Project Name: Panera
 Description: Final site plan approval and PDA recommendation
 Date on Agenda this packet pertains to: January 16, 2025

RE: Panera Bread and Retail Development- Preliminary Site Plan Review – 4th Review

RE: Panera Bread
Preliminary Site Plan – Review #3

TITLE:
STORMWATER MANAGEMENT PLAN

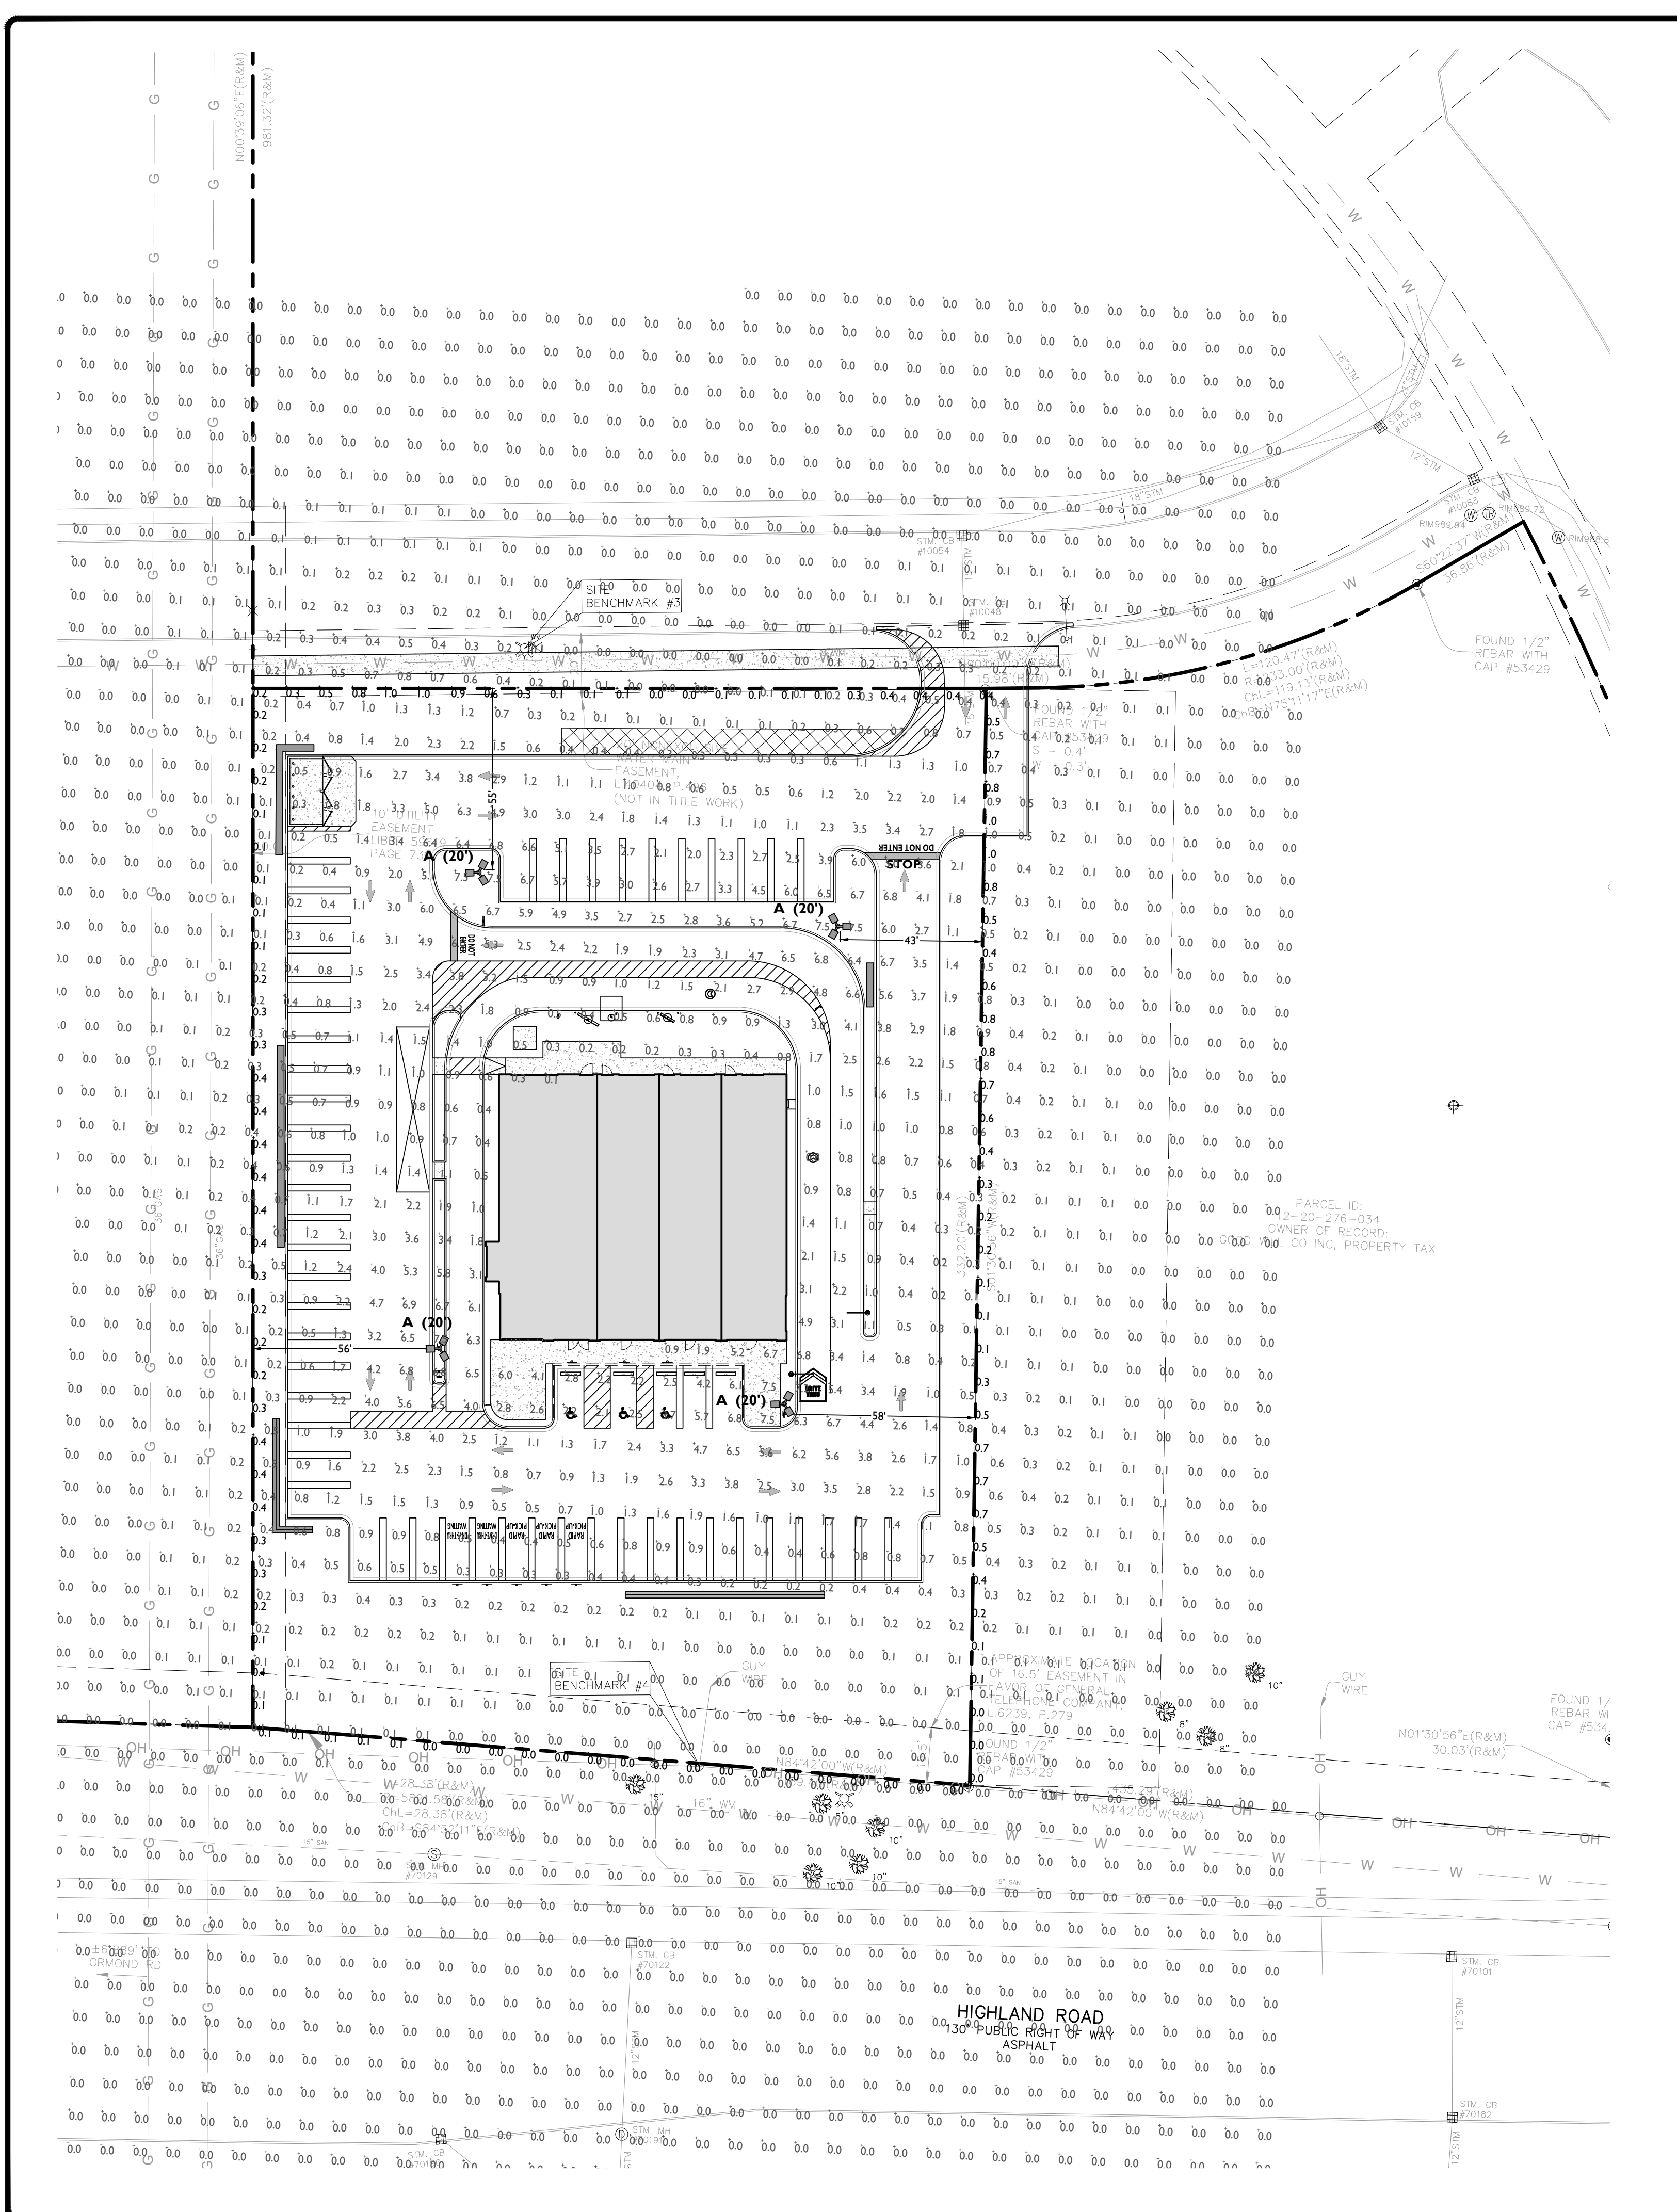
- k) Minimum time of concentration for storm sewer sizing calculations shall be 15 minutes per WLT Engineering Design Standards. This can be updated on the Final Engineering Plan (FEP) submittal package.
-

DOUBLE TRASH / RECYCLE ENCLOSURE DETAIL

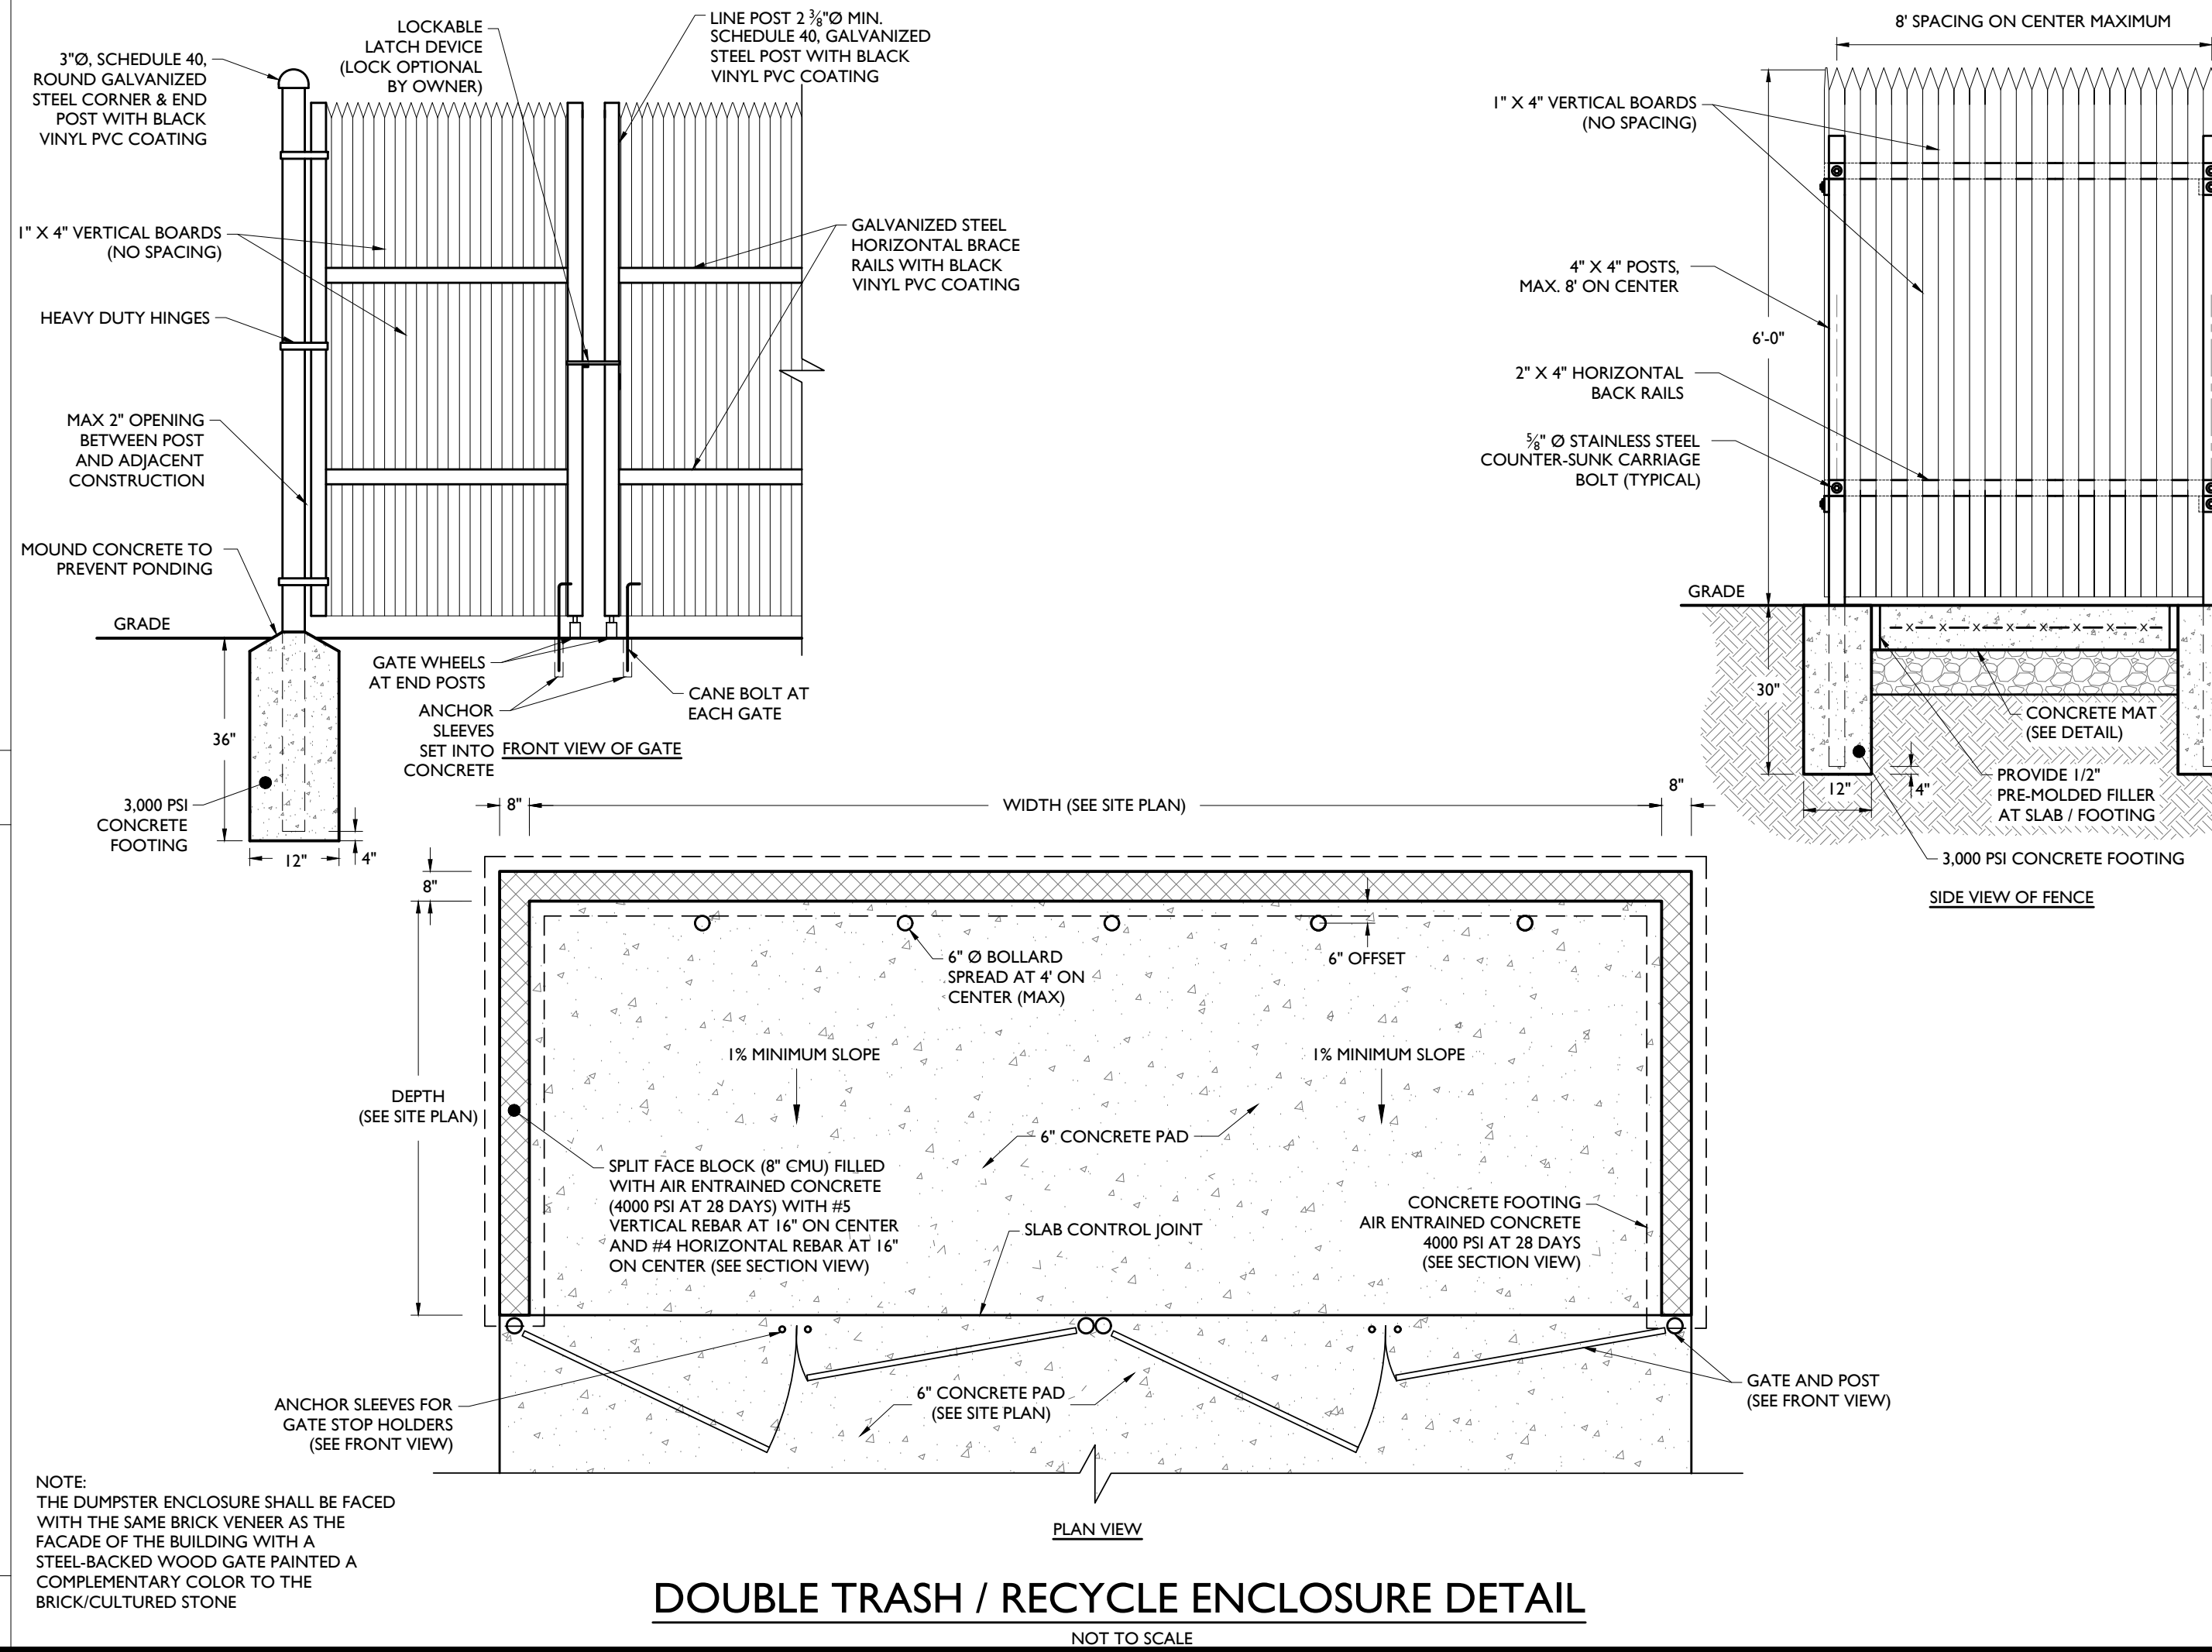
The trash enclosure detail on Sheet C-9 shall be revised to be consistent with Sheet C-3 which shows partitioning wall(s) separating the southerly third of the enclosure from the northerly two-thirds of the enclosure. Sheet C-3 shall include labels to note the type of bins to be placed in each portion of the enclosure (Comment addressed).

**INTERNATIONAL FIRE CODE
ALTERNATIVE HAMMERHEAD**

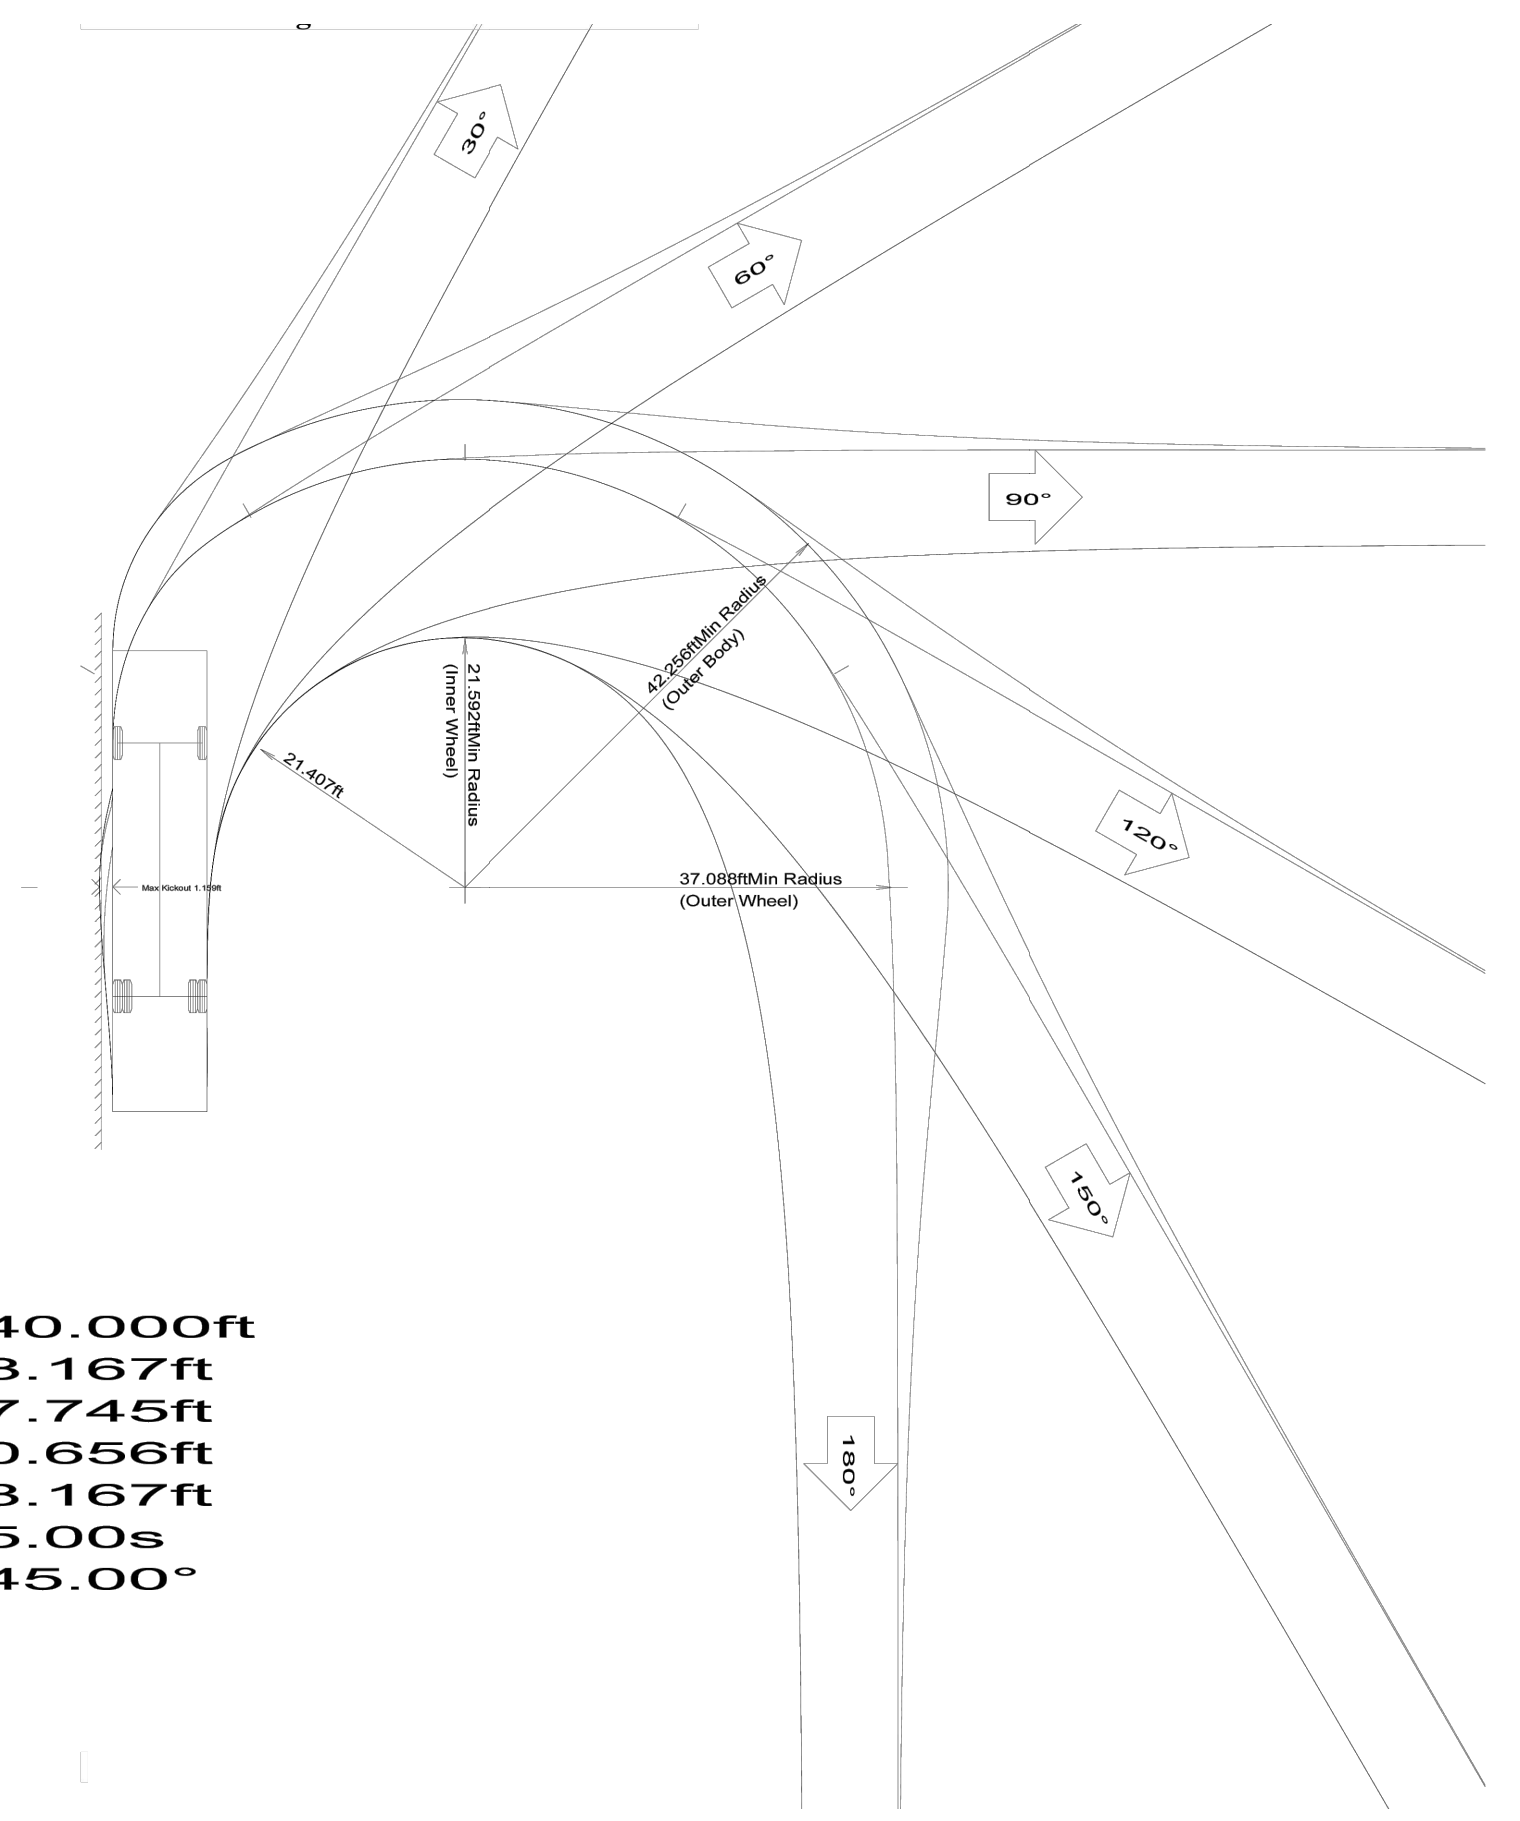
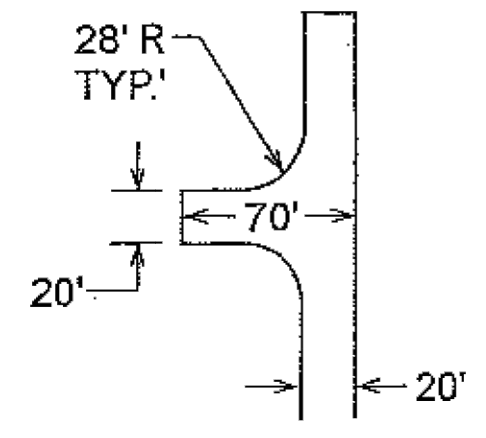
The Fire Truck Turning Exhibit (Sheet C-13) indicates a fire truck traversing over a curb, landscaping, a snow storage area, a sidewalk, and another curb to exit the site. Driving outside of designated fire lanes is not, pursuant to the zoning ordinance, acceptable for the efficient and effective use of fire apparatus (likely also noncompliant with the Fire Code). Sheet C-13 shall be revised to demonstrate fire apparatus can enter and exit the site by utilizing drive aisles/maneuvering lanes and the site driveway. Fire truck circulation is now shown on Sheet C-14. We defer to Township Public Safety on the validity of the proposed circulation however we note that there may be issues for emergency vehicles utilizing the one-way drive to the east of the building. The one-way drive aisle has been reduced in width from 20 feet to 17 feet. This does not conform to the Section 5.11.Q.v requirement that one way drive aisles be 20 feet wide. This should be corrected in the revised plan.
